**#2010-69**  
**Schafer Subdivision**  
**Project Review for the Planning and Zoning Commission**

<b><u>Meeting Dates:</u></b>	December 1, 2010
<b><u>Zoning Request:</u></b>	Final PUD / Final Plat of Subdivision for five single-family lots and one outlot.
<b><u>Location:</u></b>	1351 W. Route 176, west of Lippold Park
<b><u>Acreage:</u></b>	Approximately 7.92 acres
<b><u>Existing Zoning:</u></b>	“W-2PUD” Watershed Farming district
<b><u>Surrounding Properties:</u></b>	North: (W-2) Watershed Farming district, Sunset Meadows Park South: (County R-1) Residential district, Single-family houses East: (W-2) Watershed Farming district, Lippold Park West: (W-2PUD) Watershed Farm district, CLPD Daycare facility
<b><u>Staff Contact:</u></b>	Elizabeth Maxwell (815.356.3615)

# FINAL PLAT OF SCHAFER'S SUBDIVISION

CIVIL ENGINEERING PLANS  
FOR  
**SCHAFFER'S SUBDIVISION**  
IN  
THE CITY OF CRYSTAL LAKE  
McHENRY COUNTY, ILLINOIS

## Final Plat of SCHAFER'S SUBDIVISION

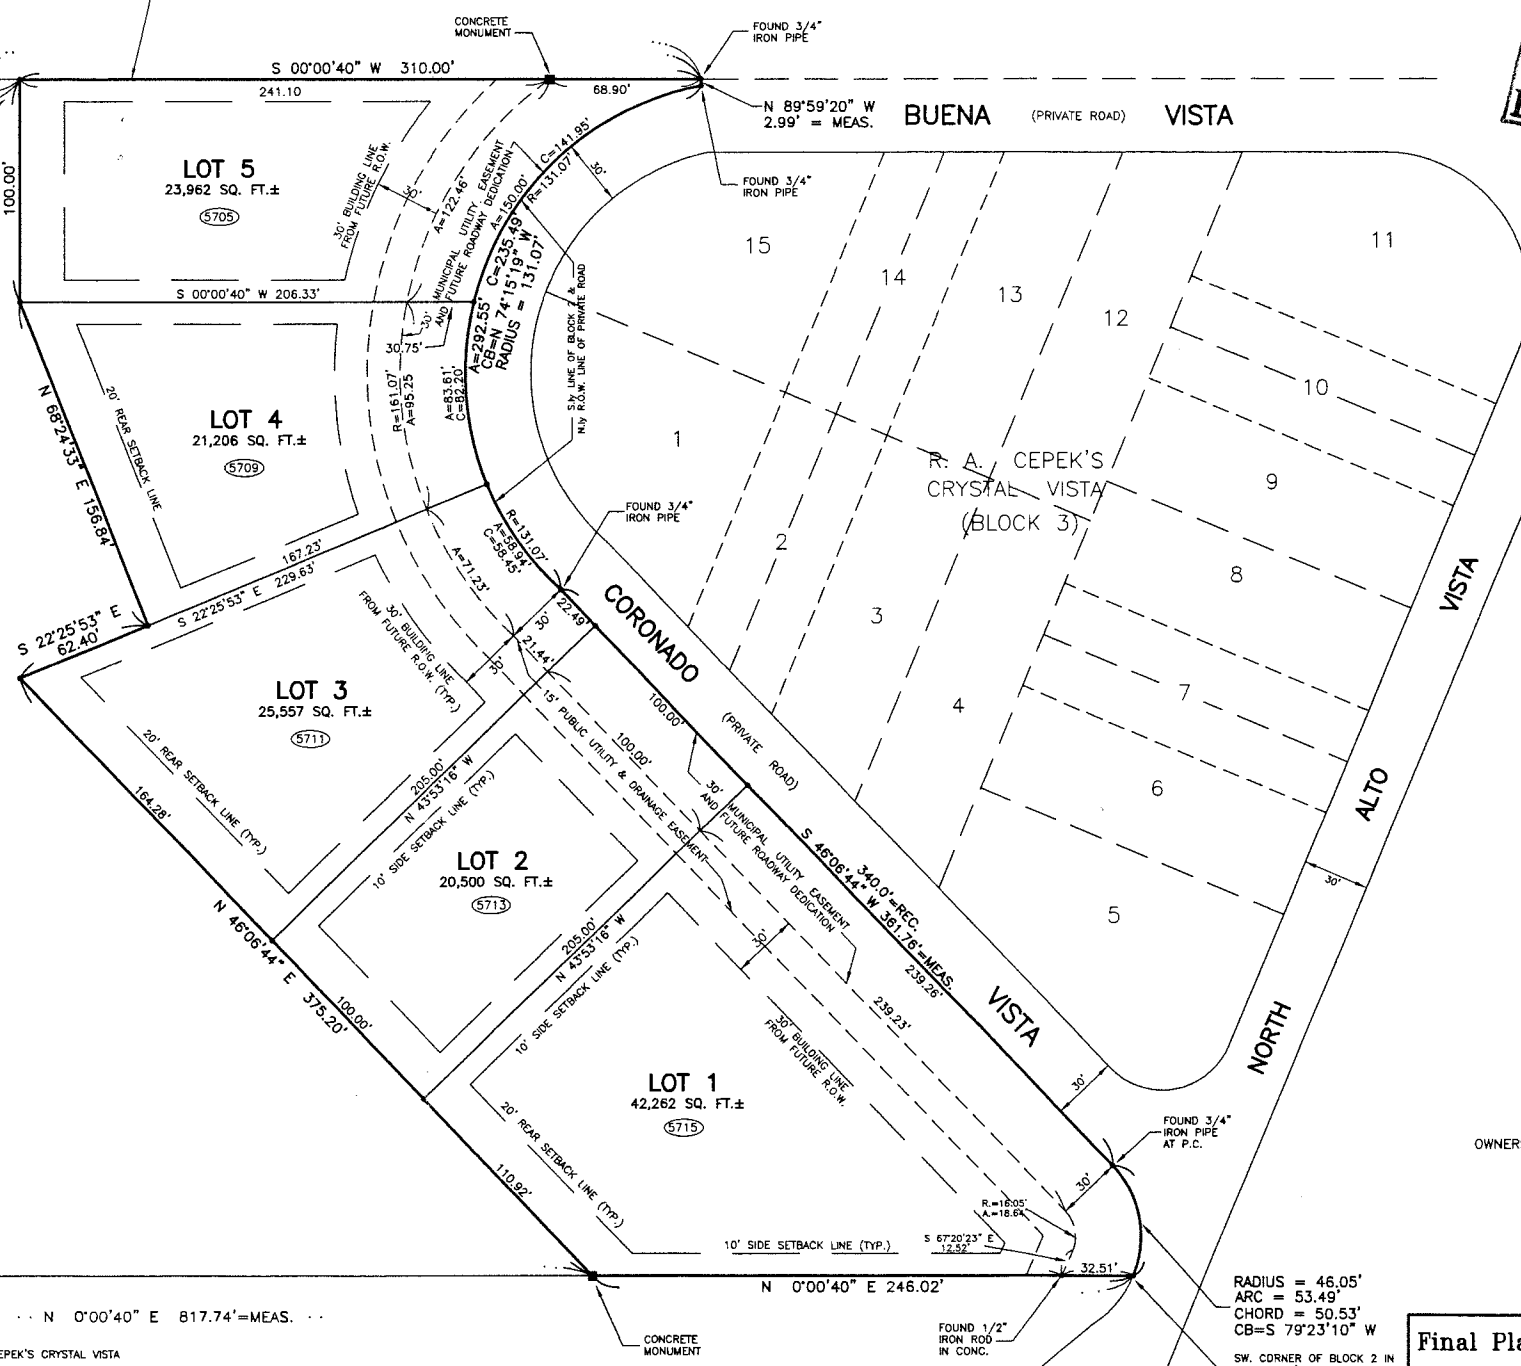
3. The Final Plat shall be amended as follows:
  - A. Add a fourth note that tree removal is not permitted within the Conservation Easement.
  - B. The outlot shall be included within the limits of the subdivision.
  - C. A Conservation Easement shall be placed over the entire development allowing for an exception of 3,418 square feet of impervious surface area on each individual lot and the easement language shall contain the language provided by staff.
  - D. Illustrate the bike path easement along Route 176.

**SCHAFFER'S SUBDIVISION  
 PLAN & PROFILE - SANITARY SEWER**

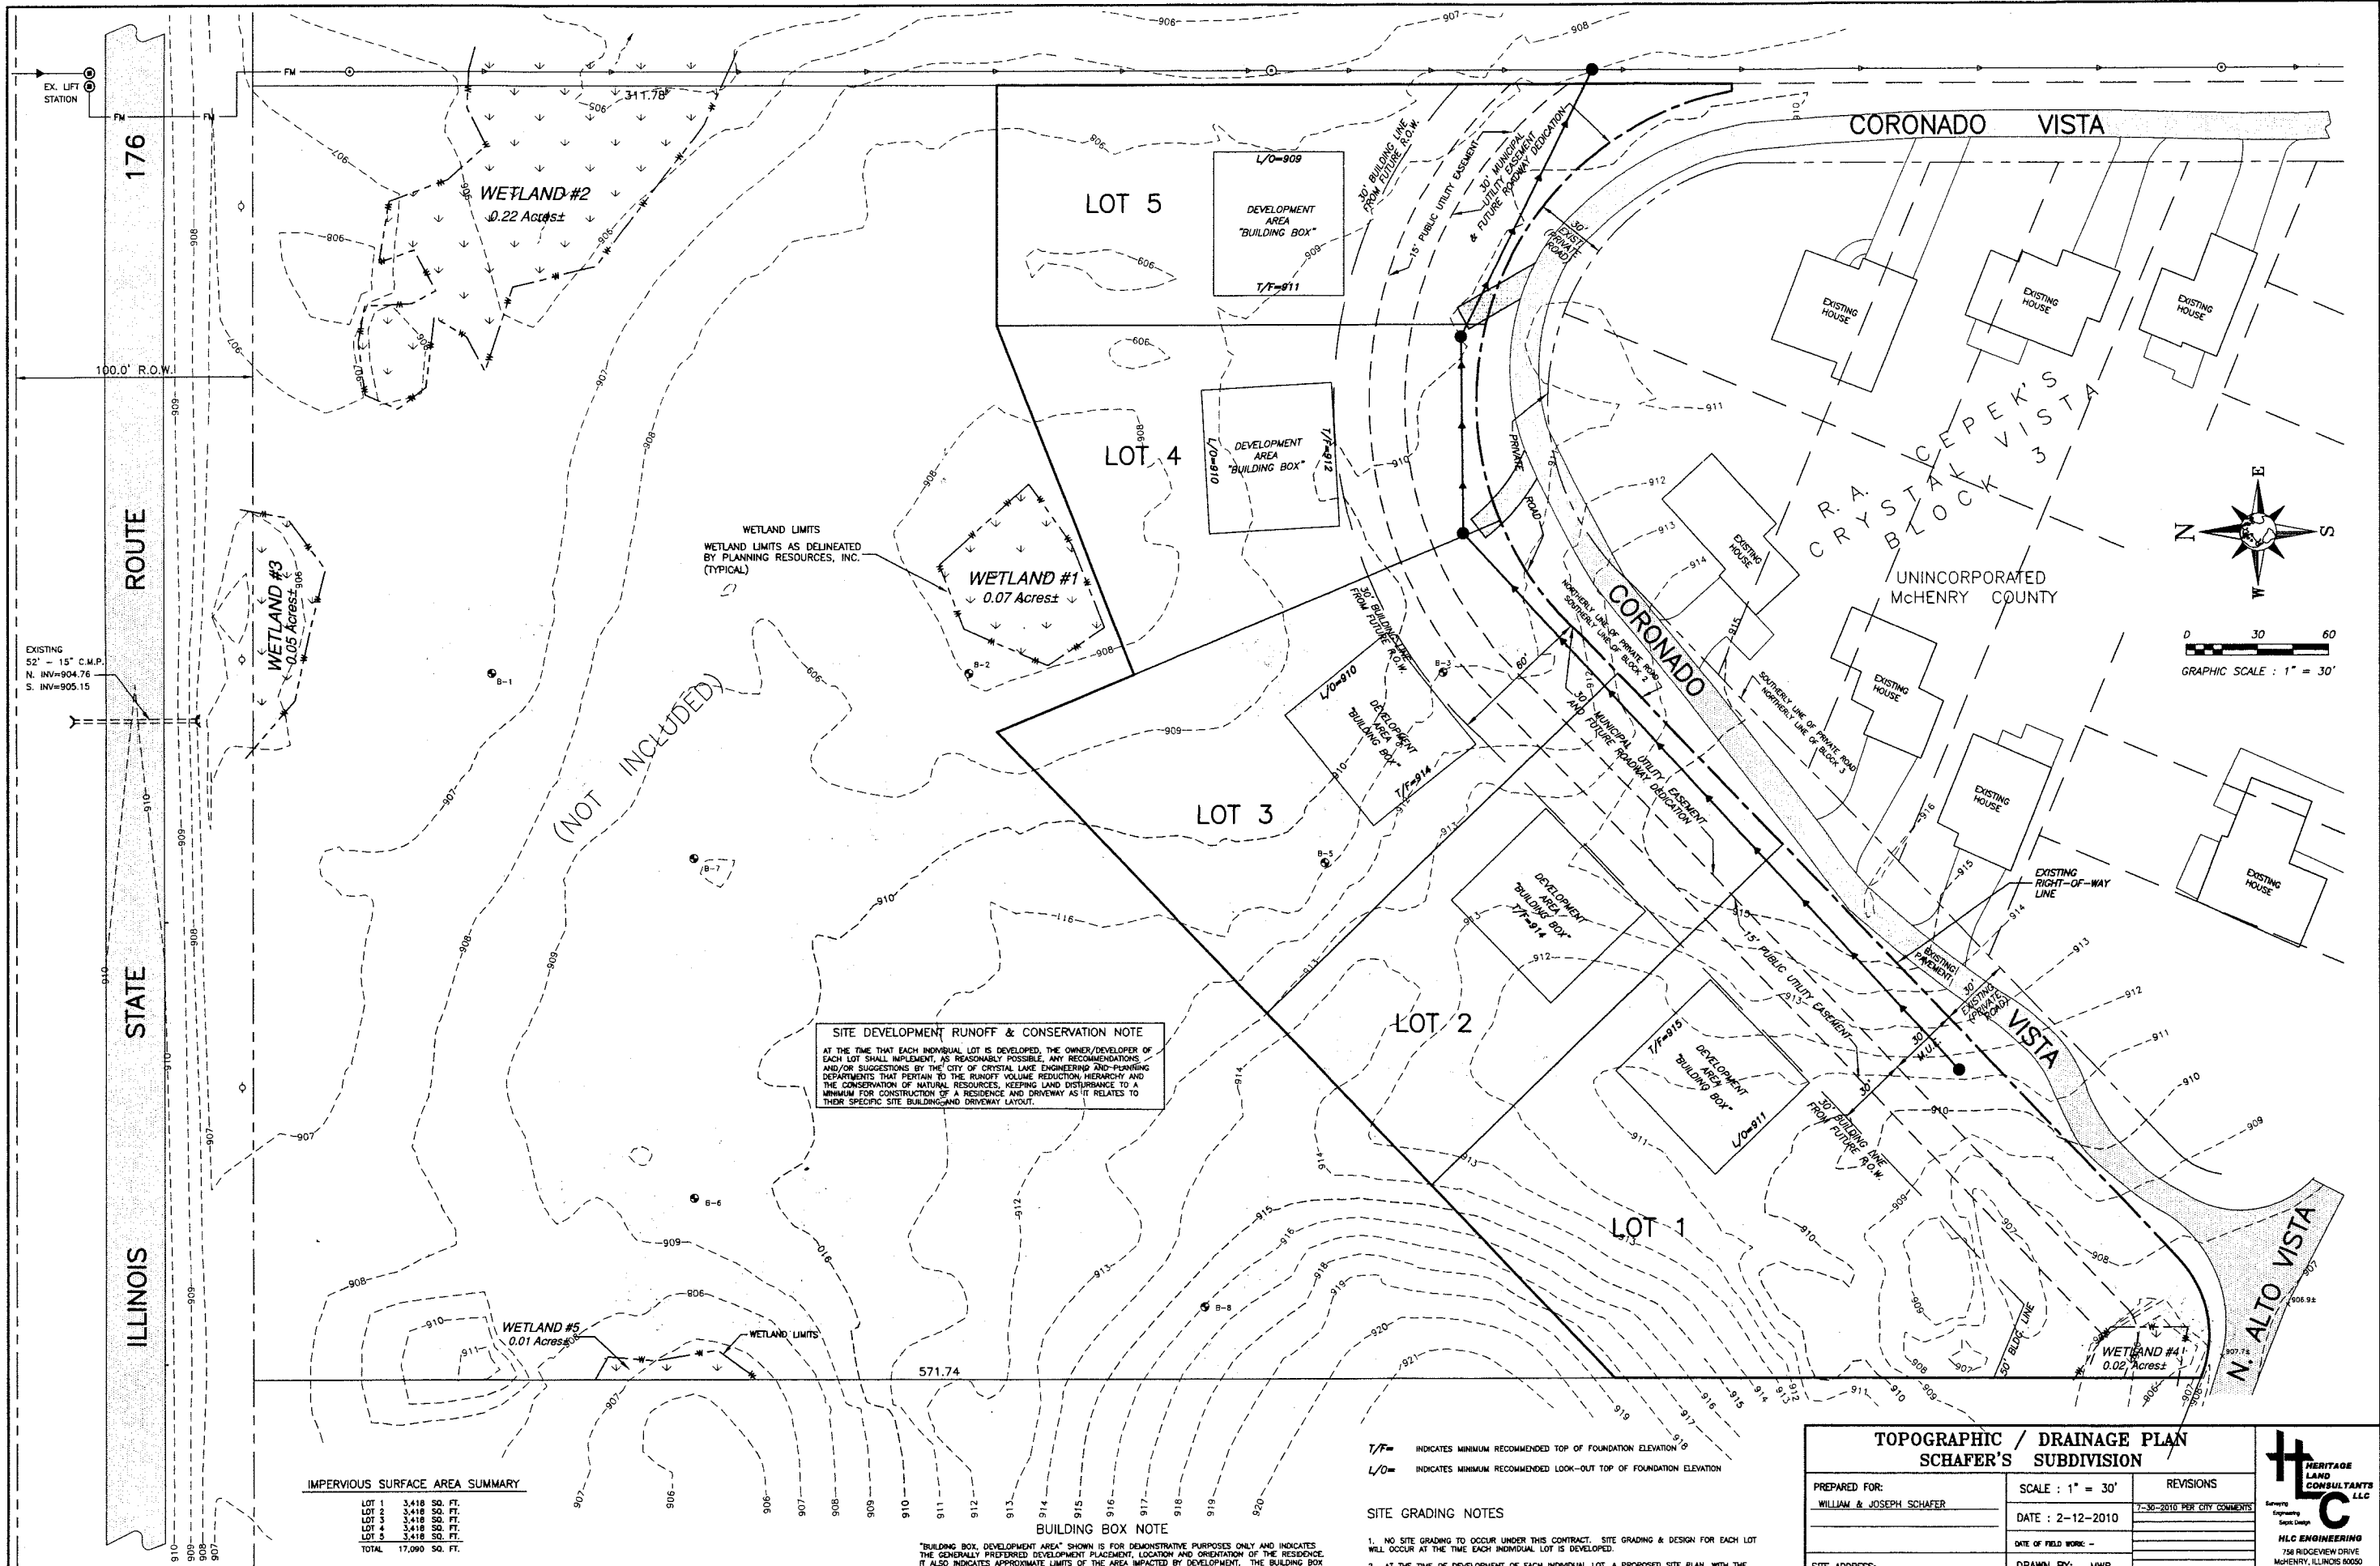
5. On sheet 3 of 6 – manhole #4 shall be relocated closer to the driveway of Lot 1. This will allow the manhole to be closer to the road and driveway in case emergency access is needed. Also 4 trees would be allowed to be saved.
6. The petitioner shall address all of the review comments of the Engineering and Building, Fire Rescue, Police, Public Works, and Planning and Economic Development Departments, as well as those of the storm water consultant.
